Public Works Department – Engineering Division

March 29, 2024

ADDENDUM NO. 1

PROJECT 8336 AMERICANA PARK BYPASS CHANNEL

CITY OF PITTSBURG
AMERICANA PARK BYPASS CHANNEL
CONSTRUCTION DETAILS - SHEET C-3
SCALE: AS SHOWN
SHEET: 7 OF 11

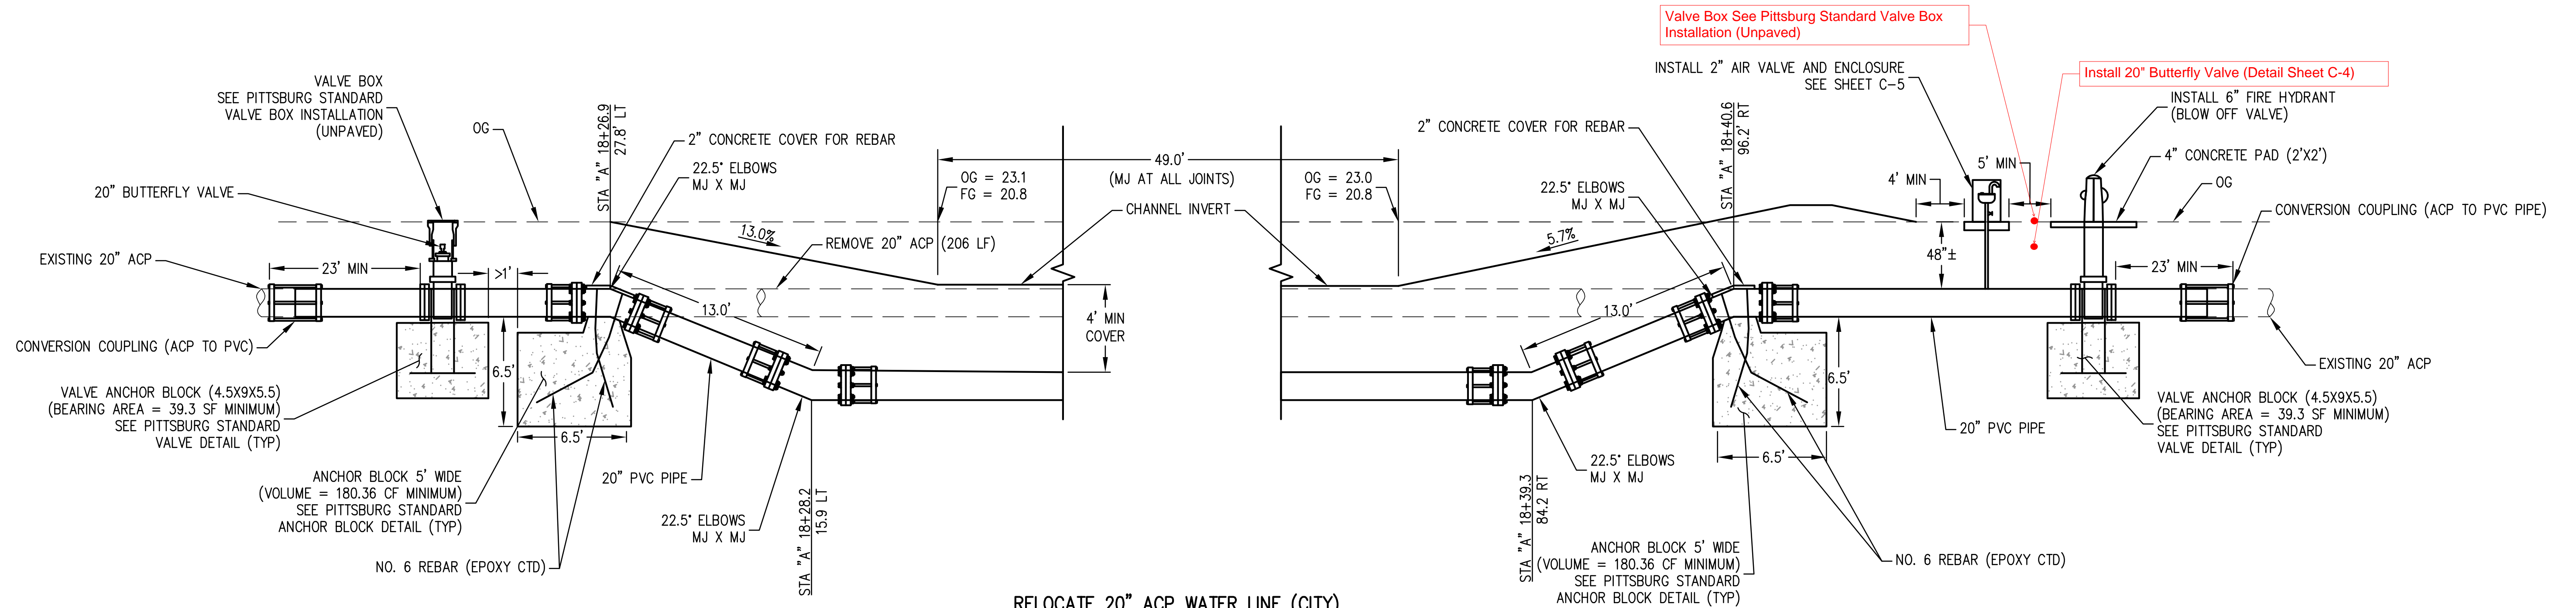
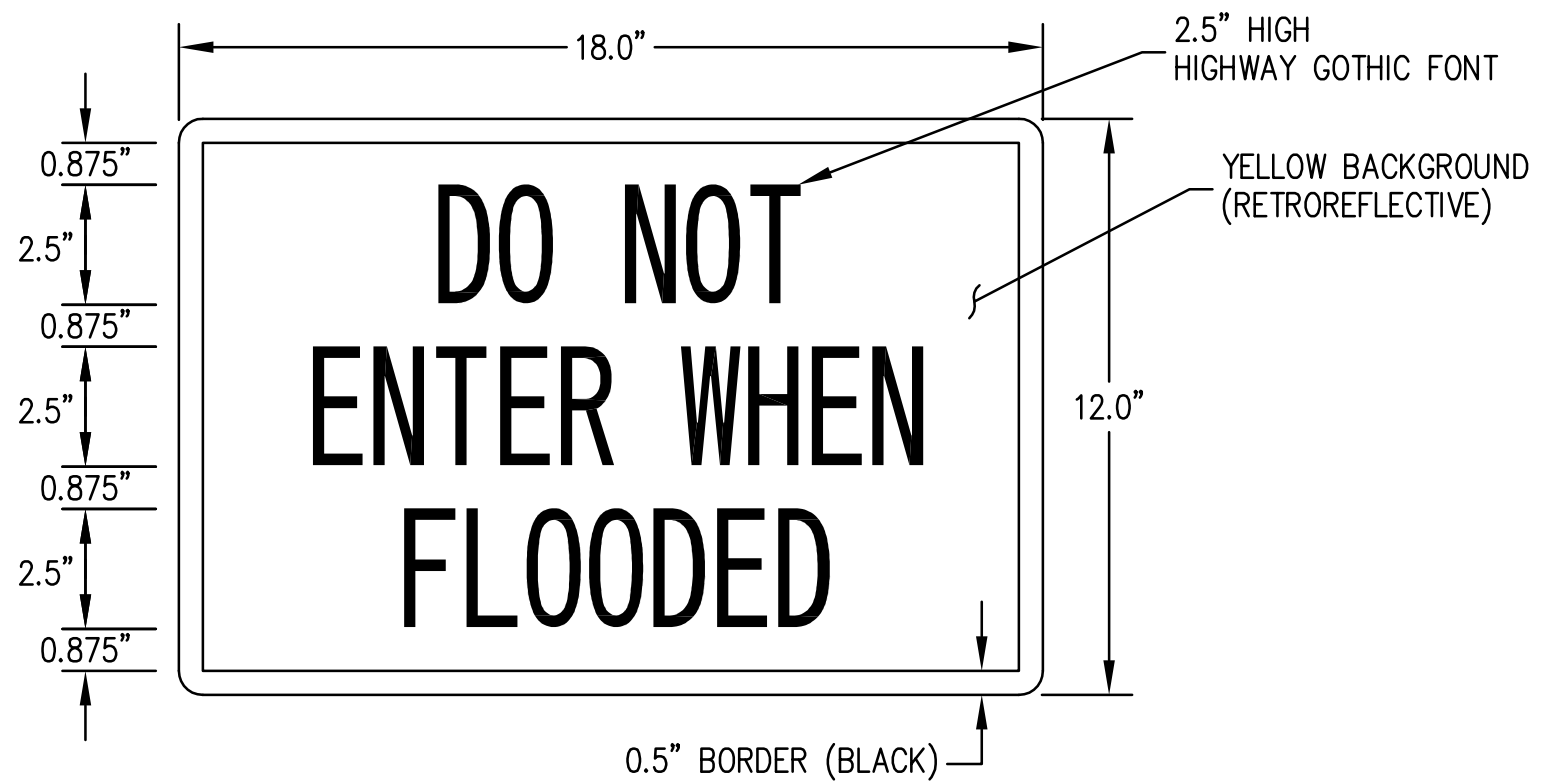
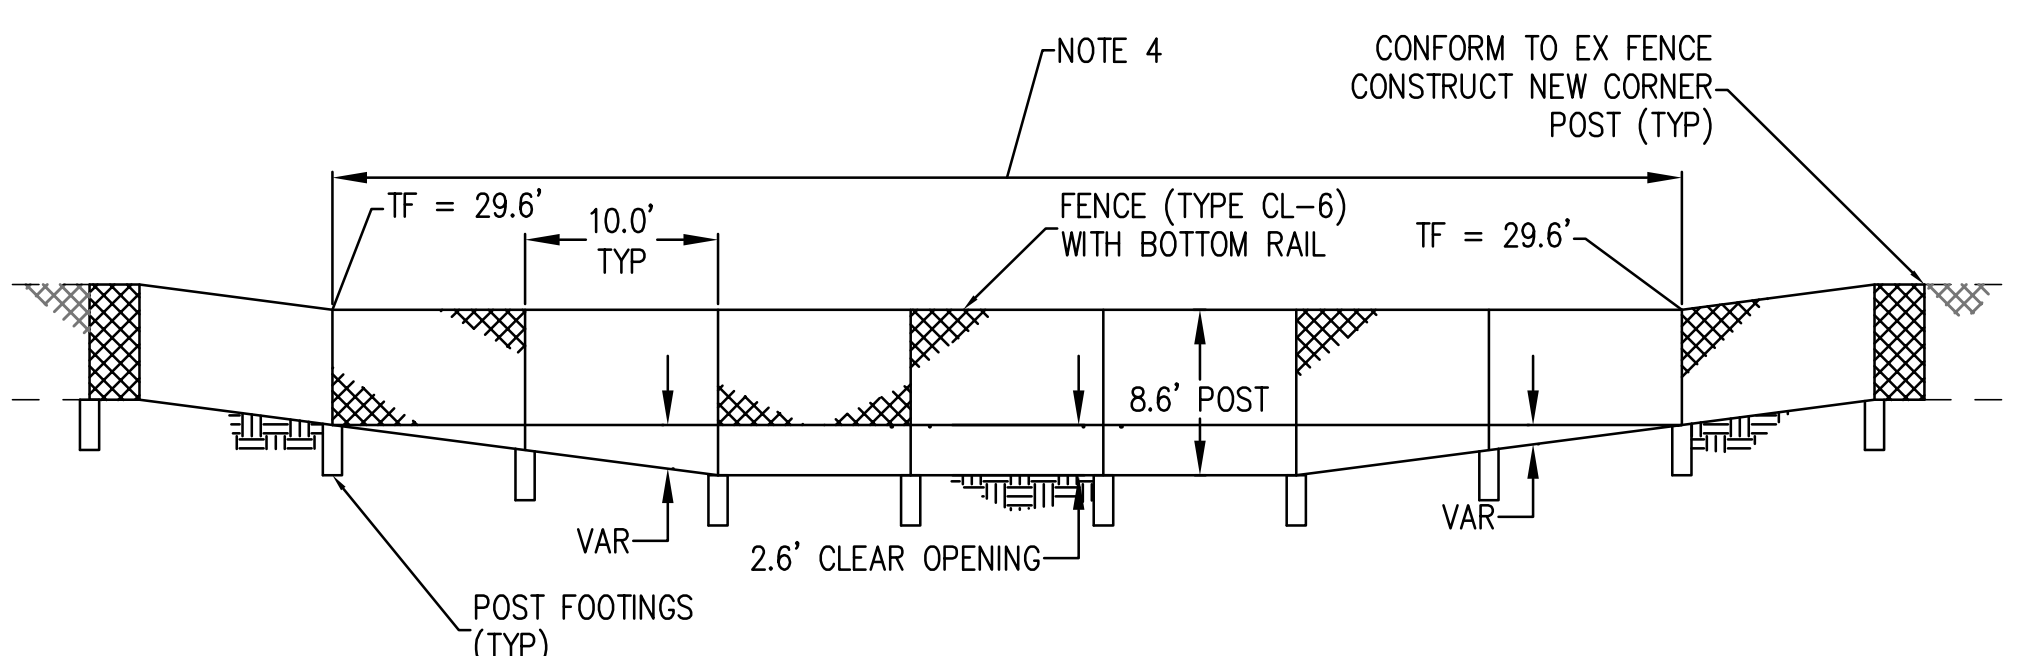
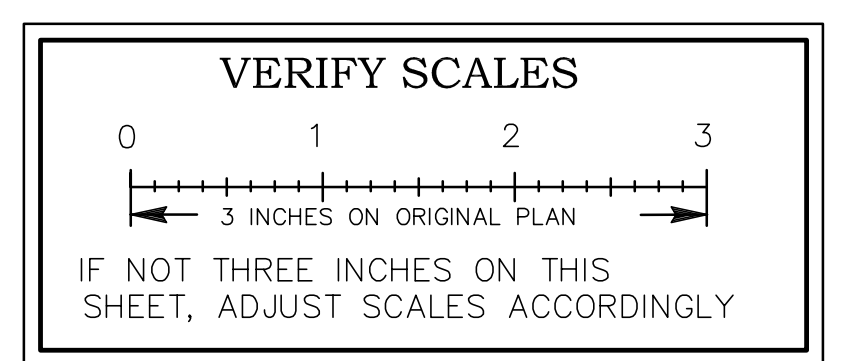
1. **Replace** the Bid Schedule – Attachment A
2. **Replace** the following Plans/Specifications:
 - a. Sheet C-3 and C-4 – Add a 20" Butterfly Valve – Attachment B
 - b. Special Provisions Section 10-1.00 Measurement and Payment, Bid Item No. 12 and 13 – Attachment C
3. As-Builts for City 20" Waterline – Attachment D

7. Please confirm the location of the two 20-inch butterfly valves. Drawing C-4 shows only one butterfly valve on the 20-inch pipe bypass segment. Drawing P-1 shows only one butterfly valve on the site layout.

13. Drawing C-3 calls out removal of trees sized at 4-inch, 6-inch, and 12-inch diameter. Based on the pre-bid site visit, it appears that these trees are considerably larger than shown on the drawings. Please confirm the removal of the existing tree sizes.

Response: Bid schedule is incorrect. There is only one 20-inch butterfly valve. However, upon further inspection, the City would like to add one more 20-inch valve as shown on the revised sheet C-3 and C-4. Refer to attachment B.

Response: The tree sizes are assumed to be greater than 12" - 48", with a total of 5 trees to be removed. See Appendix A for revised Bid Schedule.

CONSTRUCTION DETAILS - WATERLINES SHEET C-4 SCALE: AS SHOWN SHEET: 8 OF 11

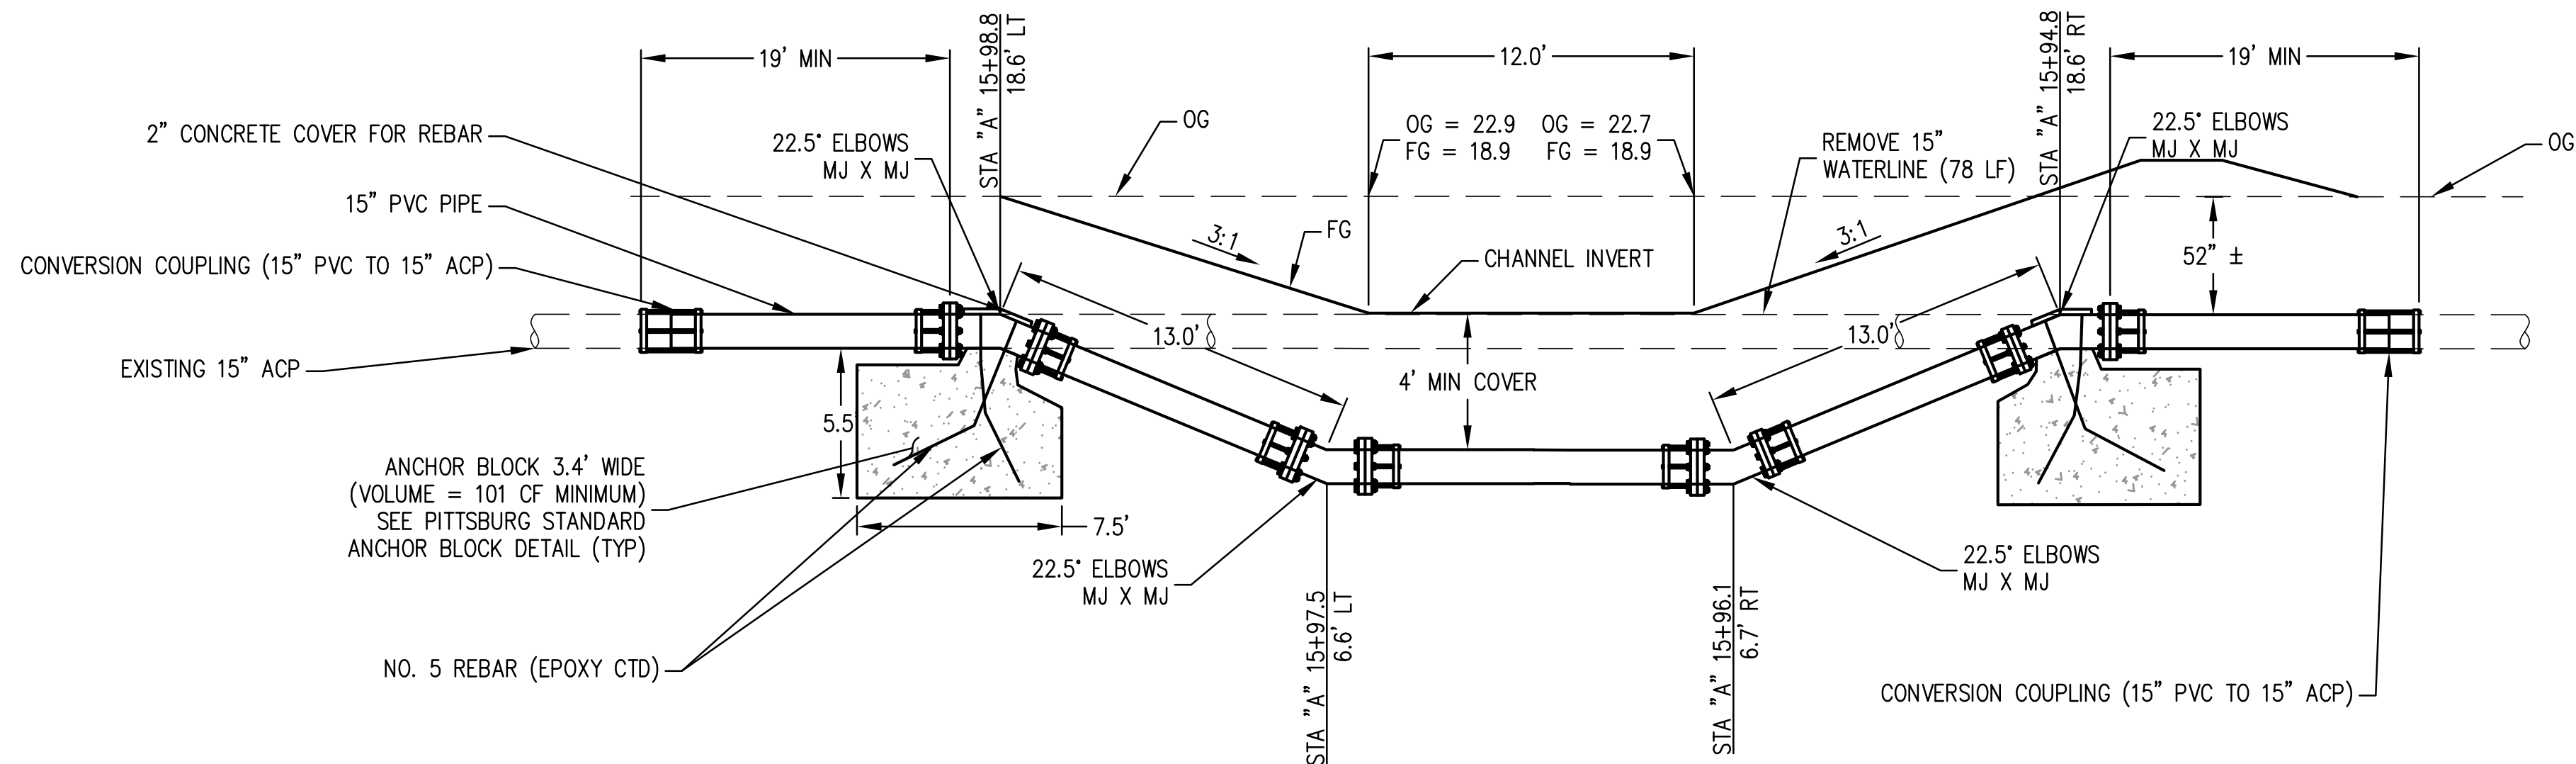
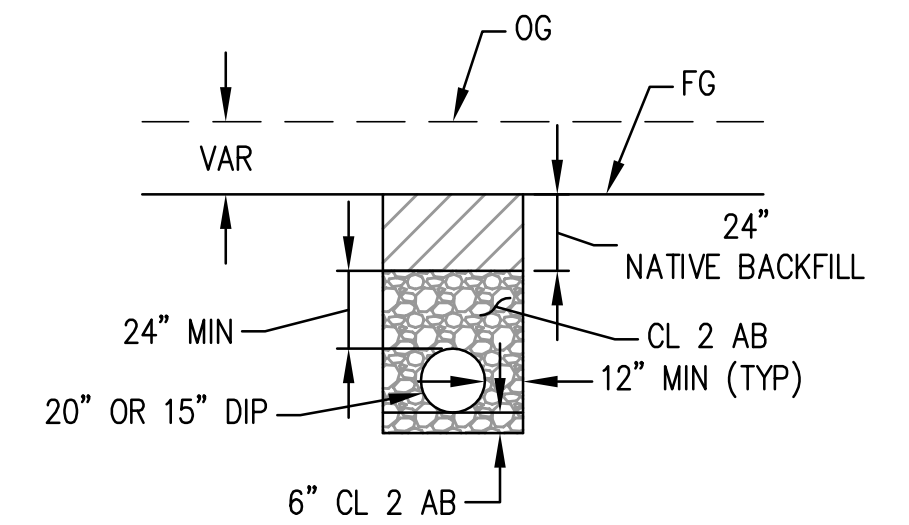
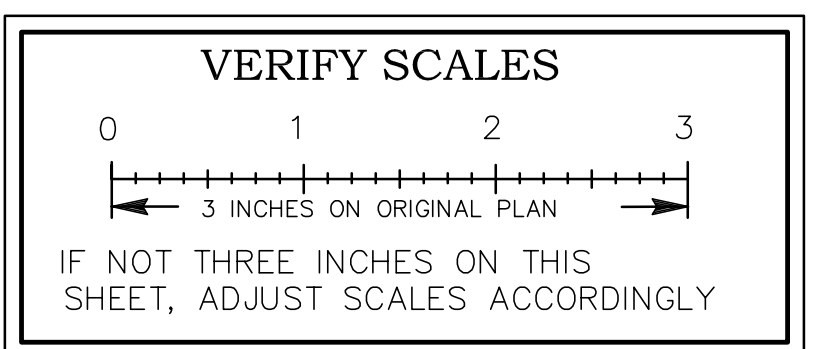
4. Drawing C-4, Note 3 states that the existing 15-inch and 20-inch waterlines can be shut down for up to 8 hours. Please clarify if multiple shutdown periods of up to 8-hours each shutdown event are allowed, or if the 8-hour limit is the cumulative allowable shutdown duration of the project.

16. The specs state that the contractor has an 8-hour window to have existing 20" and 15" water lines shut off to relocate the pipes. Is this 8-hour window referring to both pipes in the same window, or 8 hours per pipe (2 days)? Does the city intend to turn on that water immediately after relocation? This may present an issue with the curing time for concrete kickers.

Response: The City will allow for a 48-hour limit for the water shutdown.

Response: The City only owns the 20" AC Pipe. The 15" Waterline is a privately owned. The City allows up to 48 hours for the City line given the shutdown and isolation goes as planned and the residents are not affected otherwise the 8 hour window would still be in effect.
